**Committee of Experts on the Transport of Dangerous Goods
and on the Globally Harmonized System of Classification
and Labelling of Chemicals****Sub-Committee of Experts on the Transport of Dangerous Goods****Fortieth session**

Miscellaneous proposals of amendments to the**Model Regulations on the Transport of Dangerous goods: marking and labelling****Revised proposals for the descriptions of labels, placards,
symbols, markings and marks****Transmitted by the expert from the United Kingdom¹****Background**

Figure 3.4.1

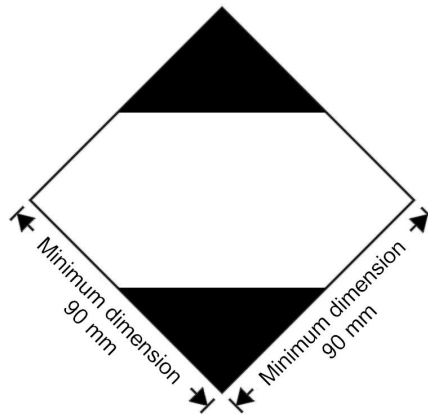
8. The United Kingdom proposes a revised version of the amended description for the Limited Quantity marking. As well as some editorial amendments, the required minimum measurement is reduced to 90 mm x 90 mm. This is to align the revised provision with the existing practical situation where adhesive labels of 100 mm x 100 mm have an LQ marking printed several millimetres from the edge of the label without a printing bleed. A similar provision applies for the reduced size label which now has a proposed minimum size of 45 mm x 45 mm. It is also proposed that the thickness of the outer border line may also be reduced in this circumstance, from 2 mm to a minimum of 1 mm. The tautological reference to “all four sides of the same length” is removed from the proposal.

The marking shall be in the form of a square set at an angle of 45 degrees (diamond-shaped) and all features shall be in proportion to those shown. The top and bottom portions and the surrounding line shall be black. The centre area shall be white or a suitable contrasting background. The minimum dimensions shall be 90 mm x 90 mm and the minimum width of line forming the diamond shall be 2 mm.

3.4.7.2 If the size of the package so requires, the minimum outer dimensions shown in figure 3.4.1 may be reduced to be not less than 45 mm x 45 mm provided the marking remains clearly visible. The minimum width of the line forming the diamond may be reduced to a minimum of 1 mm.

Figure 3.5.1

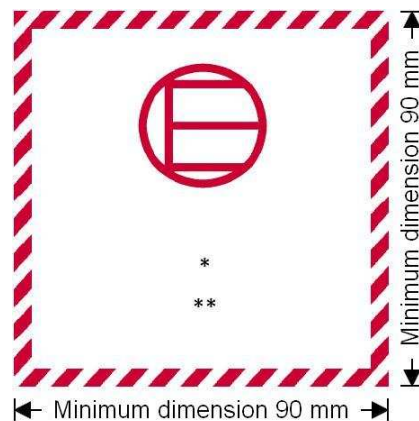
10. The background for the amendments to the provisions for the Excepted Quantity mark is explained in detail in the paper ST/SG/AC.10/C.3/2011/5. The current proposal makes some editorial amendment to the proposal. The minimum dimensions are reduced to 90 mm x 90 mm for the same reason as given for Limited Quantity markings. No changes to the text of 3.5.4.3 are proposed, but the paragraph is repositioned below Figure 3.5.1.

The marking shall be in the form of a square and all features shall be in proportion to those shown. The hatching and symbol shall be of the same colour, black or red, on white or suitable contrasting background. The minimum dimensions shall be 90 mm x 90 mm.

Figure 5.2.2

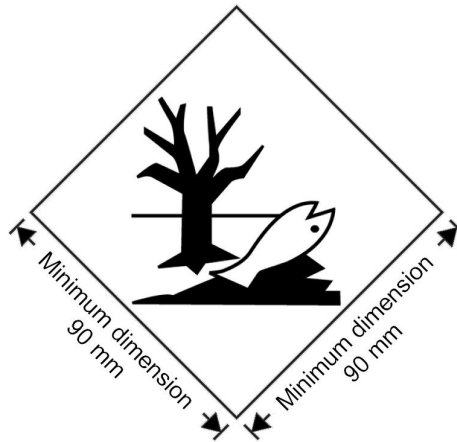
12. This proposal is amended to alter the minimum dimensions to 90 mm x 90 mm for the same reason as with the Limited Quantity marking. A reduction for the larger labels for Cargo Transport Units is to 240 mm x 240 mm is also for this reason. These are also the same dimensions as the line inside the inner edge on placards. The text “with all four sides the same length” is also removed from the proposal. The colour is specified as black. This is not currently specified in the text, but would appear to be intent of Figure 5.2.2.

The marking shall be in the form of a square set at an angle of 45 degrees (diamond-shaped) and all features shall be in proportion to those shown. The symbol (fish and tree) shall be black on white or suitable contrasting background. The minimum dimensions shall be 90 mm x 90 mm and the minimum width of line forming the diamond shall be 2 mm. If the size of the package so requires, the dimensions/line thickness may be reduced, provided the marking remains clearly visible.

5.3.2.3.2 The environmentally hazardous substance mark for cargo transport units shall be as described in 5.2.1.6.3 and Figure 5.2.2, except that the minimum dimensions shall be 240 mm x 240 mm. The minimum width of line forming the diamond shall be 5 mm.

Figure 5.2.5

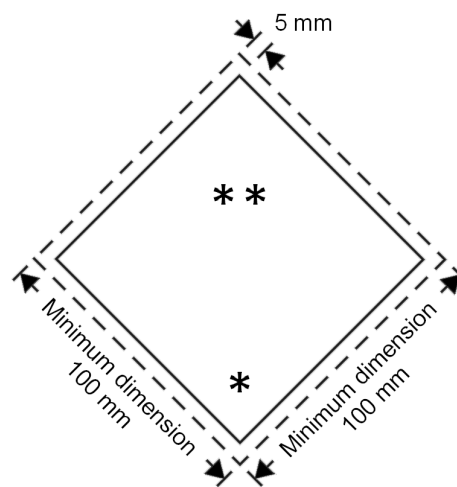
16. This proposal has only one revision from ST/SG/AC.10/C.3/2011/5; to specify that the measurement from the edge of the label to the line inside the edge be measured to the outside of that line. The expert from the United Kingdom notes that is the current measurement used on label samples that have been examined, but is open to altering this part of the proposal if preferred. No printing bleed is used for these labels, so the overall minimum dimensions remain at 100 mm x 100 mm.

5.2.2.2.1.8 If the size of the package so requires the dimensions may be reduced, provided the marking remains clearly visible. The line inside the edge shall remain 5 mm to the edge of the label. The minimum width of the line inside the edge shall remain 2mm. Dimensions for cylinders shall comply with 5.2.2.2.1.2.

The label shall be in the form of a square set at an angle of 45 degrees (diamond-shaped) with all four sides the same length. The minimum dimensions shall be 100 mm x 100 mm and the minimum width of the line inside the edge forming the diamond shall be 2 mm. The line inside the edge shall be parallel and 5 mm from the outside of that line to the edge of the label. The line inside the edge on the upper half of the label shall be the same colour as the symbol and the line inside the edge on the lower half of the label shall be the same colour as the class or division number in the bottom corner.”

Figure 5.3.0

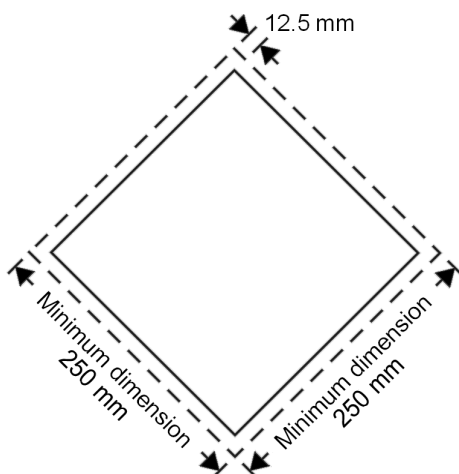
18. Both these alternative proposals have been revised in a similar way to proposal 5 to make the outer edge of the inner line the point of measurement. Likewise, the UK is open to amending this part of the proposal if this is the will of the UN Sub-Committee.

19. The description follows that proposed for class/division labels as closely as possible. To avoid altering the logical structure of the provisions, some references to labels remain in the descriptive text.

The placard shall be in the form of a square set at an angle of 45 degrees (diamond-shaped) with all four sides the same length. The minimum dimensions shall be 250 mm x 250 mm (to the edge of the placard outside a holder) and the minimum width of the line inside the edge forming the diamond shall be 5 mm. The line inside the edge shall be parallel and 12.5 mm from the outside of that line to the edge of the label. The symbol and line inside the edge shall correspond in colour to the label for the class or division of the dangerous goods in question. The class or division symbol/numeral shall be positioned and sized in proportion to those prescribed in 5.2.2.2 for the corresponding class or division of the dangerous goods in question. The placard shall display the number of the class or division (and for goods in class 1, the compatibility group letter) of the dangerous goods in question in the manner prescribed in 5.2.2.2 for the corresponding label, in digits not less than 25 mm high."

Figure 6.5.1

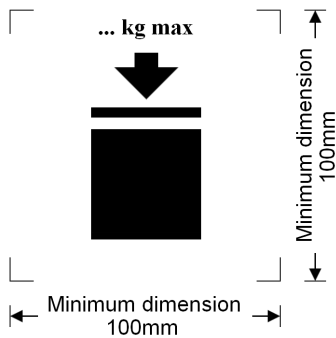
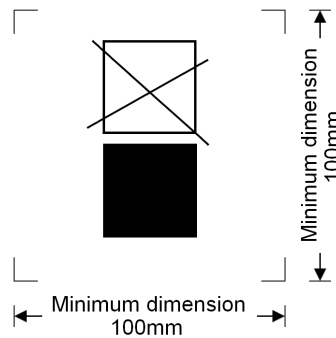
25. The proposal for stacking load symbols is clarified to make clear that the area within the printer’s marks should be square. This would ensure that the symbols remain in proportion. For situations where the printer’s marks are not printed on an IBC or large packaging, the requirement for the symbol to be in proportion to 100 mm as shown in the example diagram gives an indication of the minimum required size. From a practical point of view, printers have the discretion to increase the size used to ensure the marking is large enough when printing the symbols without a printer’s mark. The United Kingdom is reluctant to specify the dimensions of the symbols themselves due to the complexity involved in doing so. This would also change recently adopted approach from the 17th revised edition of the Model Regulations.

The minimum dimensions shall be 100 mm x 100 mm. The letters and numbers indicating the mass shall be at least 12 mm high. The area within the printer’s marks shall be square and all features shall be in proportion to those shown.”

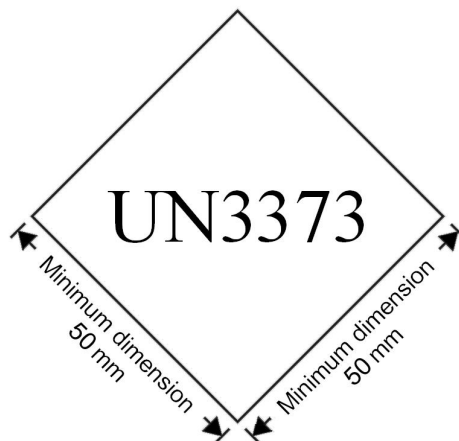
28. Packing Instruction P650 includes a simple mark consisting of a diamond with the lettering "UN3373" inside. The specification allows latitude in the sizing of the lettering and numbers, which can be smaller in proportion to the diamond than is shown in the diagram. This paper does not propose to change this, so no text prescribing that the features be in proportion to the diagram is proposed. It is only proposed that dimensional arrows be added in line with the other diamond shaped markings in the Model Regulations.

29. The same issue relating to printing bleeds may exist for this marking as for the Limited Quantities markings (see proposal 1). If the Sub-Committee judges it necessary, the Expert from the United Kingdom would be open to reducing the minimum dimensions to 45 mm for the same reasons given for the Limited Quantities markings.

30. Amend the diagram in P650 as follows (overall size of diagram increased to allow for the size of dimensions lettering/arrows):
